**RINGSEND TO CITY  
CENTRE CORE BUS  
CORRIDOR**

**NTA OBSERVATIONS  
ON COMPULSORY  
PURCHASE ORDER  
OBJECTIONS**

November 2023

Figure 2-1: Extract from CPO Deposit Map Sheet 11

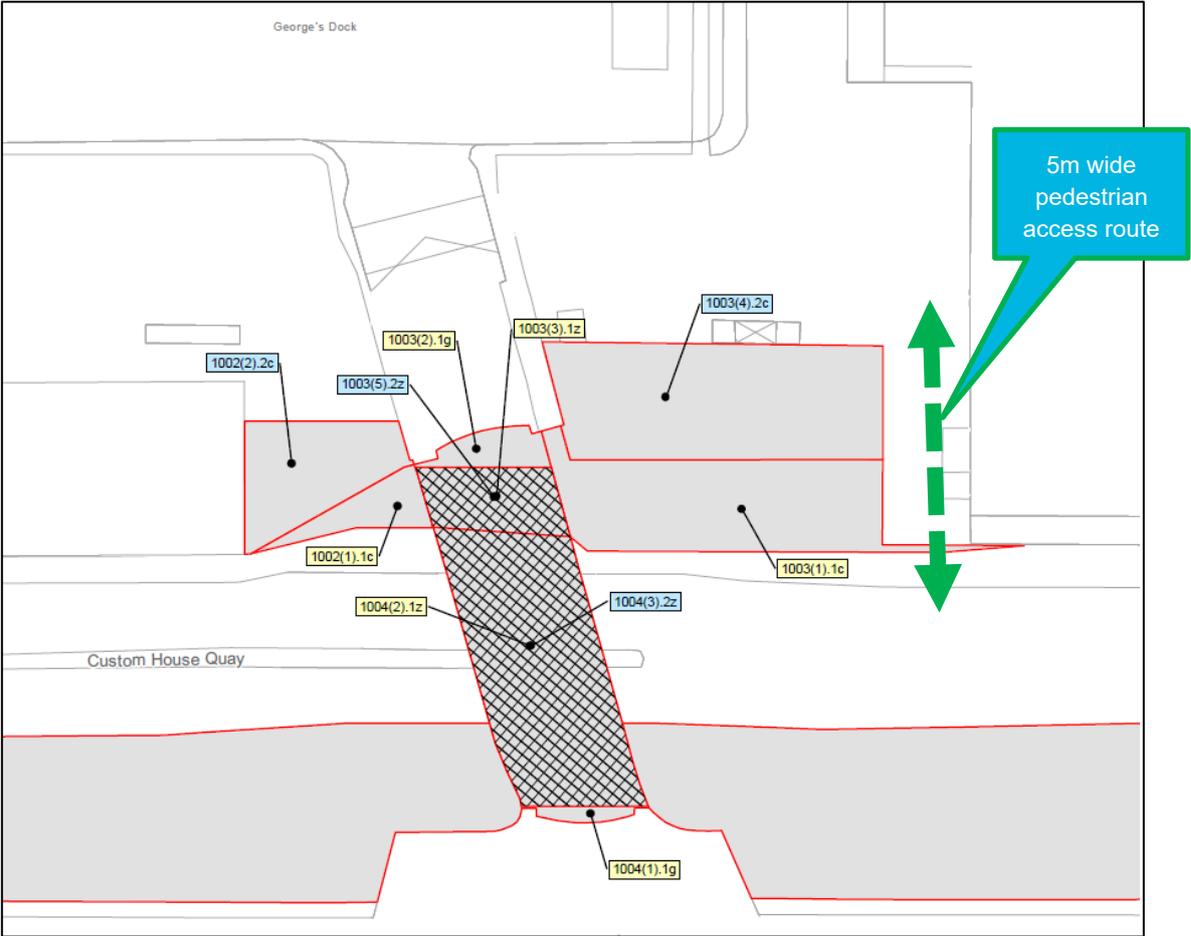
- Temporary CPO for the construction compound, associated noise and disruption from the compound, and the duration of the temporary acquisition.
- Reduced pedestrian access in 5m wide strip between the proposed compound and the CHQ building.
- Drainage culvert under the plaza area and the proposed relocation of the Scherzer Bridge.
- Ownership and maintenance of the bridge?
- Concern about access to car park beside Memorial Bridge junction.
- Impact for value of lands.

As is annotated on Figure 2-1 earlier, a 5m wide pedestrian access route will be retained between the eastern edge of the proposed construction compound and the nearest edge of the CHQ building, where there is an emergency exit stairwell on the western side of the building.

Figure 2-7: Revised Image 5.2 from EIAR Chapter 5 with Compound Area Corrected

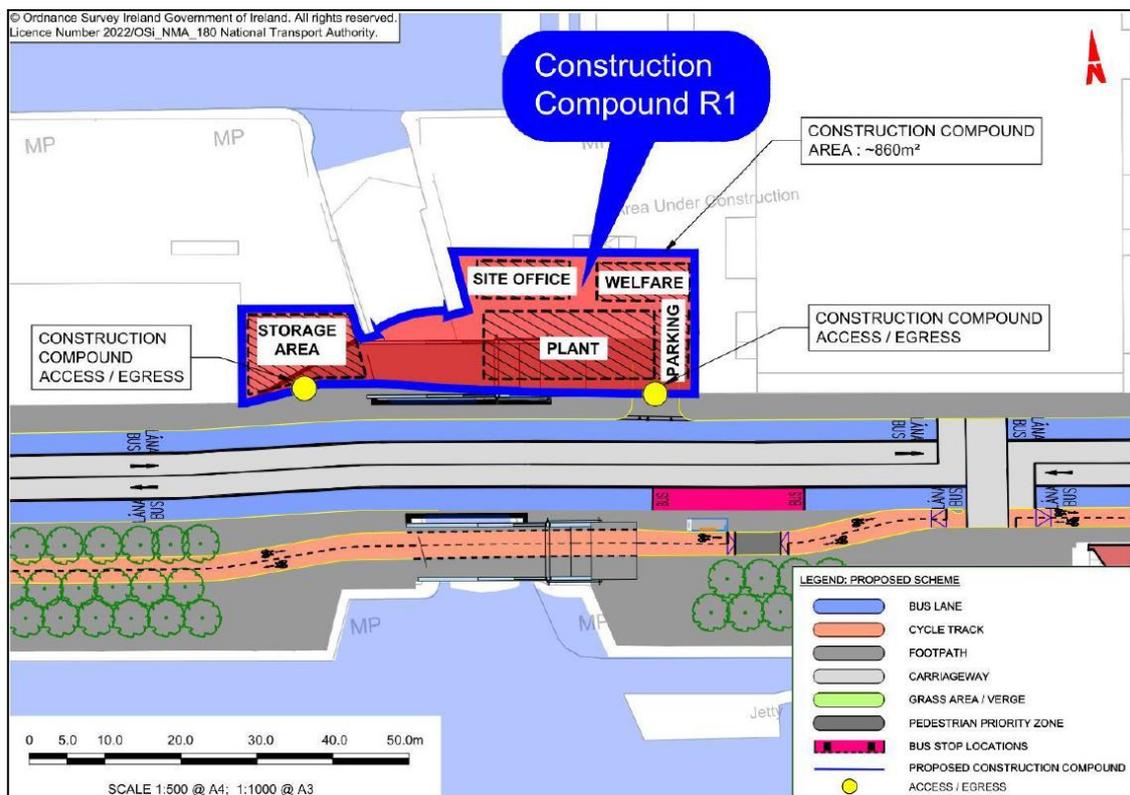
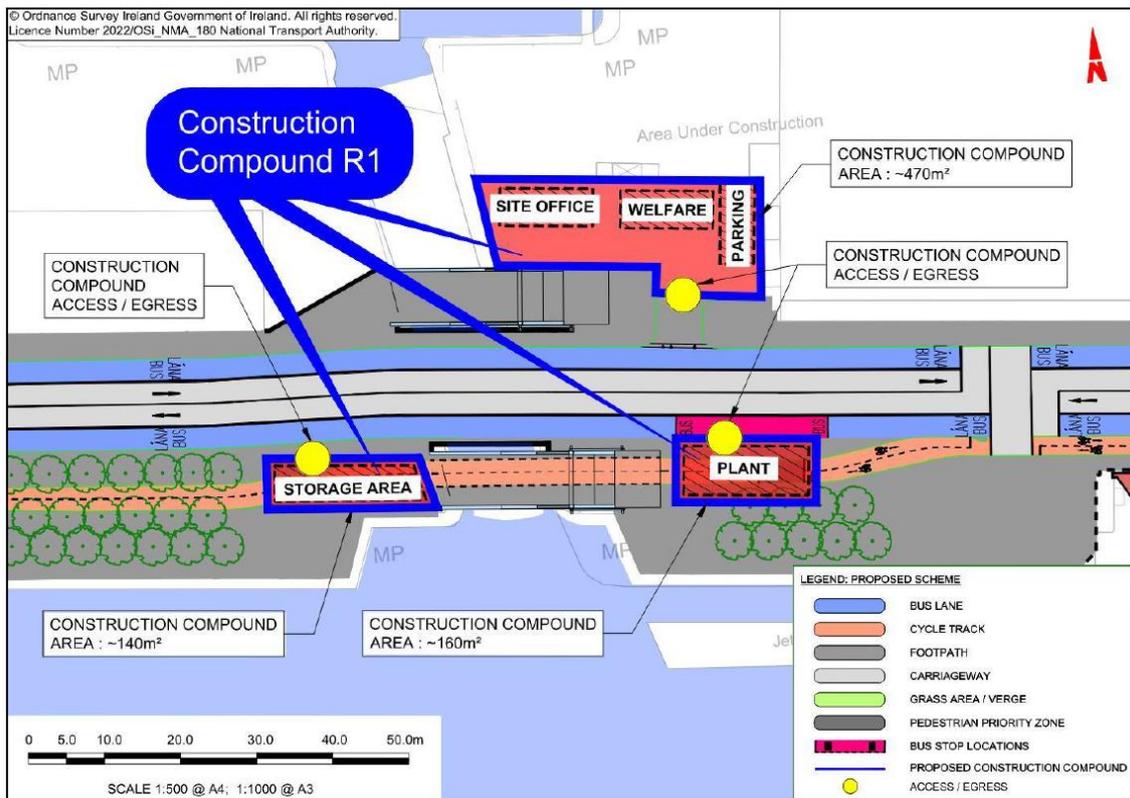
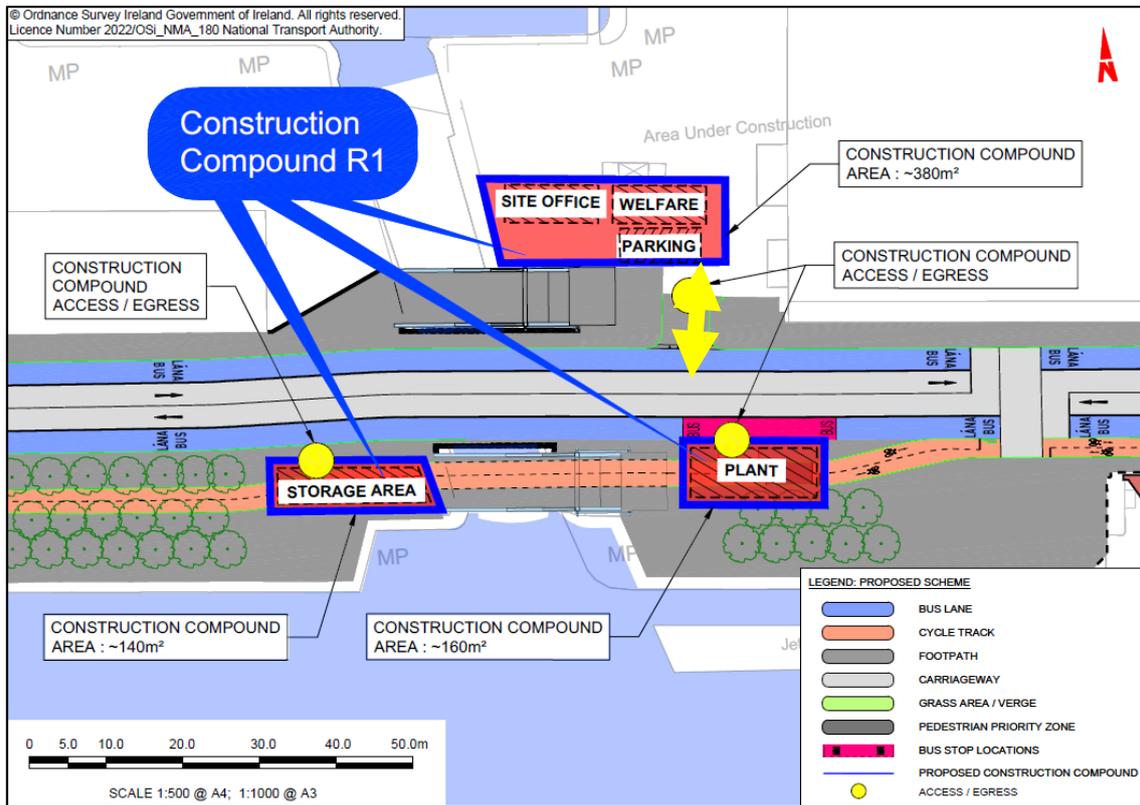
There is a discrepancy between Images 5.1 and 5.2 as included in EIAR Chapter 5, which shows the northern part of Construction Compound R1 to occupy a larger area in Image 5.2 than in Image 5.1. This was an error in Image 5.2, and a corrected version is shown in Figure 2-7 below, where the footprint is the same as in Image 5.1. In this respect the compound is required to fit within the boundaries of CPO Plot No.1003(4).2c as shown in Figure 2-8.

**Figure 2-7: Extract from EIAR Volume 3, Chapter 4 Drawings Part 2, General Arrangements, Sheet 1**

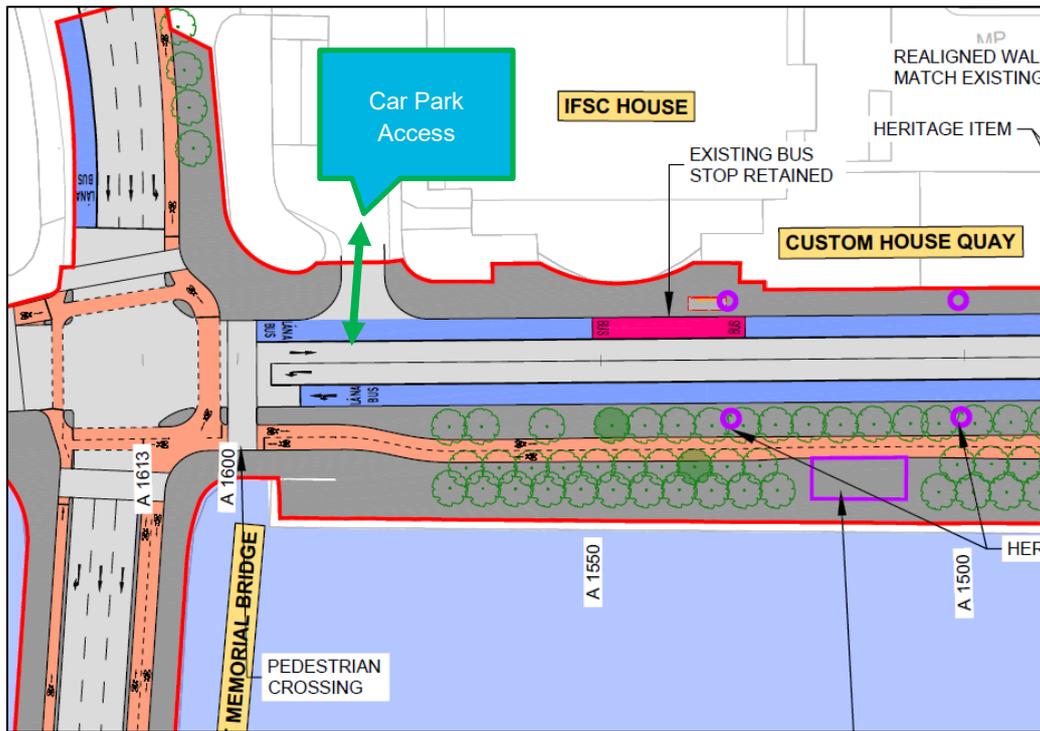
e) Access to car park beside Memorial Bridge junction.

This existing car park access is at the western end of the proposed scheme as shown in Figure 2-7. It will not be affected by the proposed scheme and access will continue to be available across the proposed eastbound bus lane.

Figure 2-17: Extract from General Arrangement Map Sheet 3

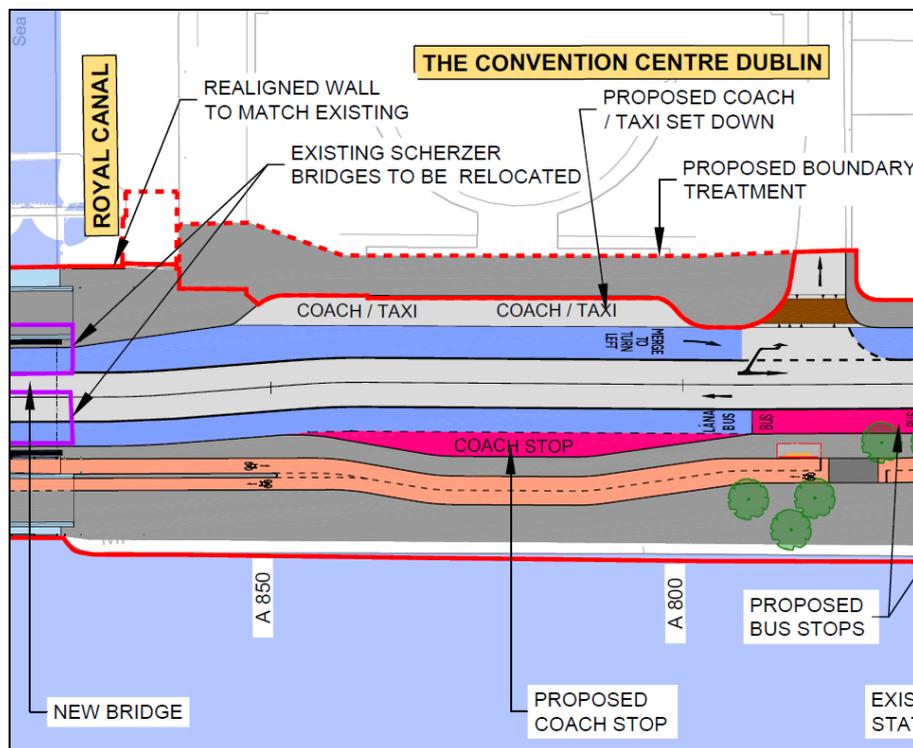
- a) Seeks clarification about the proposed use of the Coach/Taxi layby in front of the Convention Centre.

The proposed scheme will retain the existing layby at the Convention Centre for continuation of the existing function to cater for passengers alighting from and boarding coaches and taxis. Parking will not be permitted. During the construction period some short term traffic management restrictions will be necessary for pavement repair works on the road in front of the convention centre, but access to at least part of the layby will be retained as much as possible.
